Engine Mount Fatigue Cracks

EFFECTIVITY**MODEL-** Ranger R7**SERIAL NO:** ALL AIRCRAFT WITH SERIAL NUMBER LESS THAN 10203**REASON**

SB-12-06-22-1 REV C
Page 7 of 25

Appendix A: Inspection Of Engine Mount

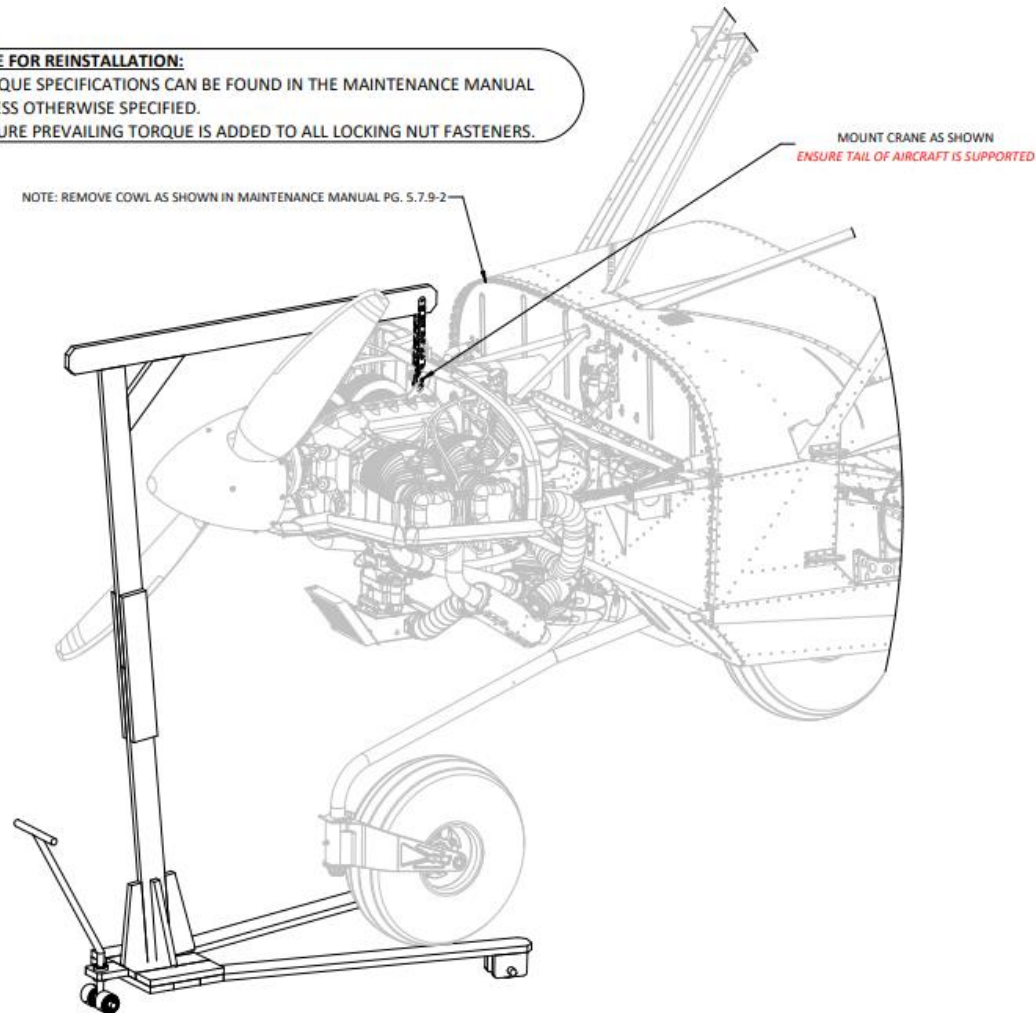
Fatigue cracks have been reported on the engine mount lug welds caused by insufficient weld fillets. This issue has been traced back to batch of aircraft with serial number identified above.

Inspect the engine mounting weldment for cracks.

Mandatory before further flight. If no cracks are present the following intervals are valid:

- Inspect at interval of 10hrs flight time since service bulletin effectivity.
- After two 10hrs inspection (20hrs total), inspect every 25hrs of flight time.
- Once two 25hrs inspections (total 70hrs) have been conducted, the inspection interval can be same as annual maintenance period (every 100hrs).

DETAIL D

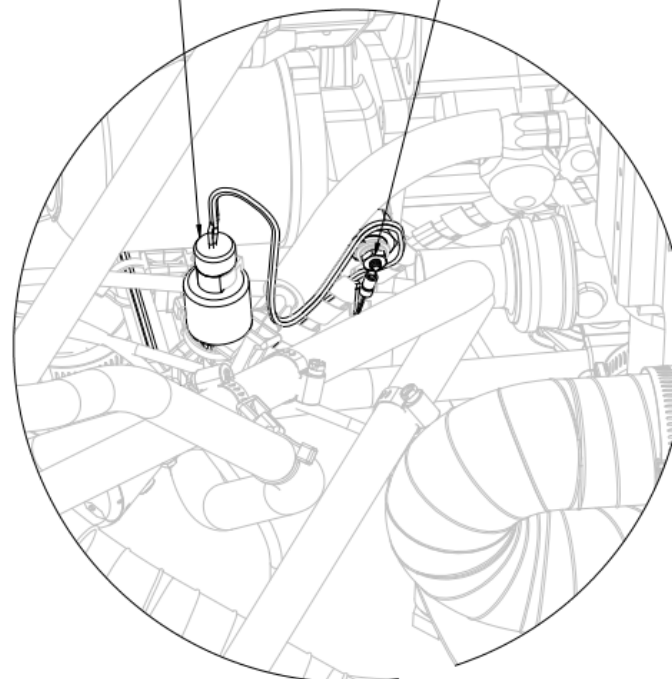
UNPLUG OIL PRESSURE SENSOR AT CONNECTOR

DISCONNECT OIL TEMPERATURE SENSOR AT TERMINAL

DETAIL F

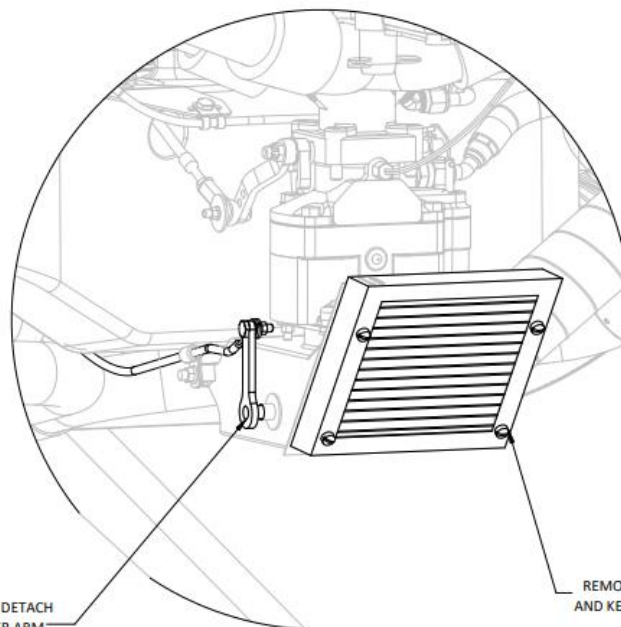
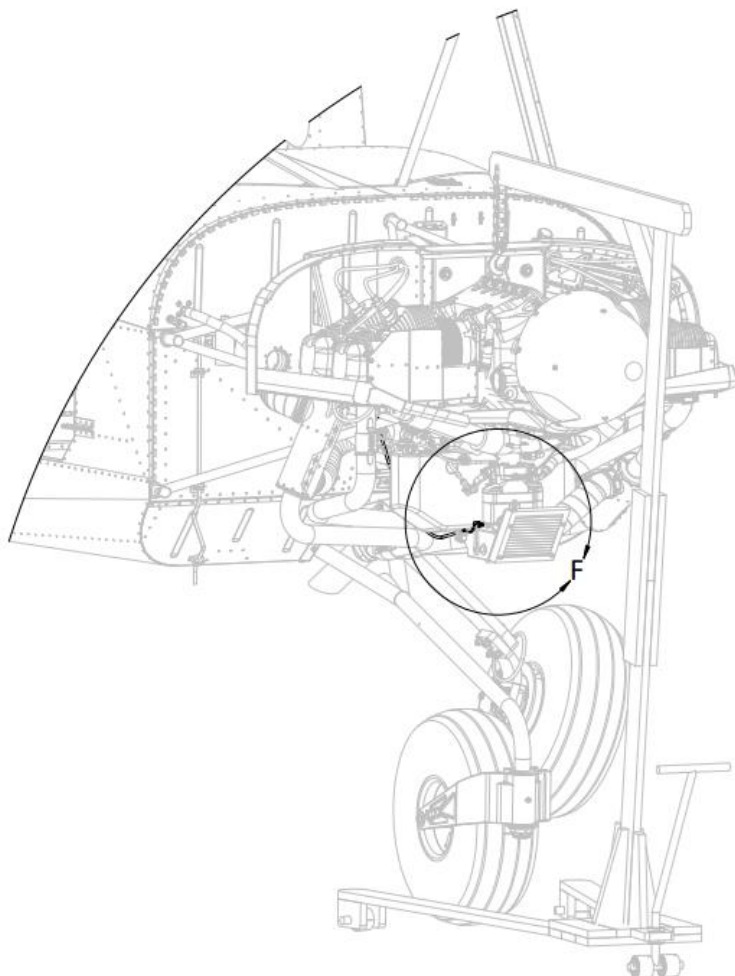
REMOVE BOLT TO DETACH
CARB HEAT LEVER ARM
AND KEEP ALL HARDWARE

REMOVE AIR FILTER
AND KEEP HARDWARE

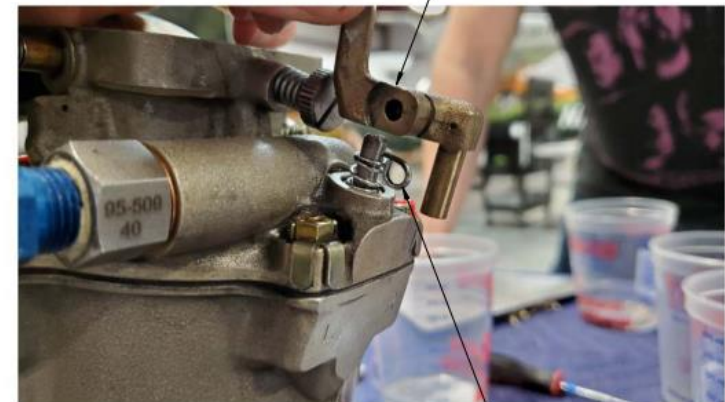
REMOVE SCREW AND KEEP.
(NOTE: ARM WILL POP UP WHEN SCREW IS REMOVED)

REMOVE CONTROL ARM STILL
ATTACHED TO MIXTURE CABLE

NOTE: DO NOT LOSE SPRING AND KEY

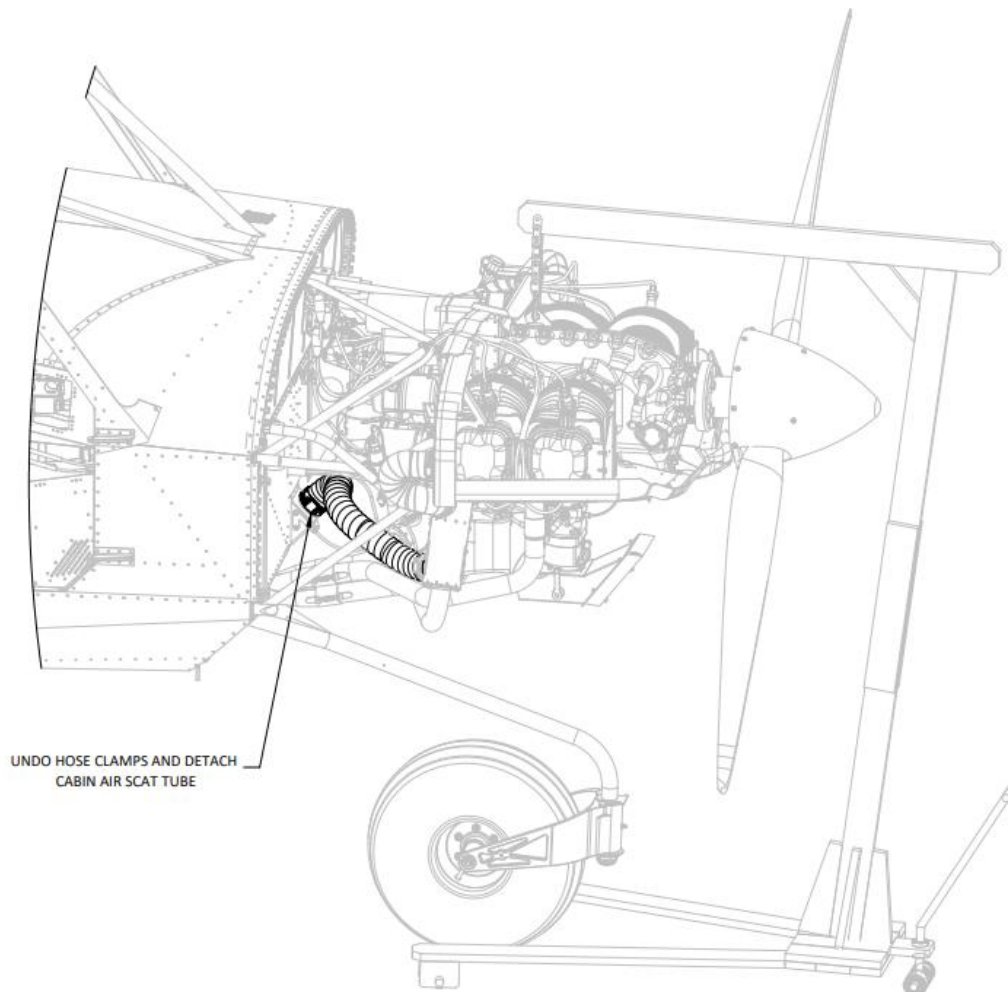
DURING REINSTALLATION; REPLACE AND CLAMP WASHER FLANGES.
MCFARLANE PART NUMBER 78-A109
